Access Compliance Report

Public Rights-of-Way

Intersection ID: N/A	Main Street: KELYN_HILLS_DR	Cross Street: KINLEY_COMMONS_LN	Location: E
ADA ID: 3EE8523AB060	Ramp Type: BlendTrans1	Initial Pass/Fail: Fail	Overall Compliance: No
Codes/Mitigation Info/Possible Solution		Field Measurements/Component Compliance	
Severity Score: 10

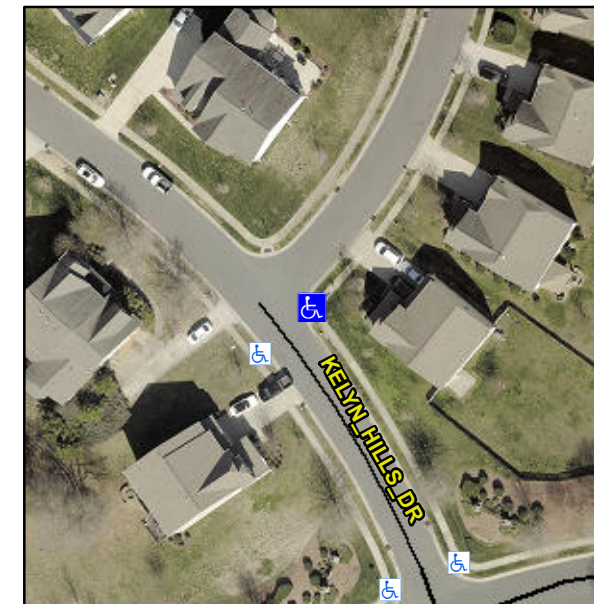
Not Found, R304.5.1, R304.5.3

Remove & Replace Curb Ramp With Two New Directional Ramps or Equivalent.
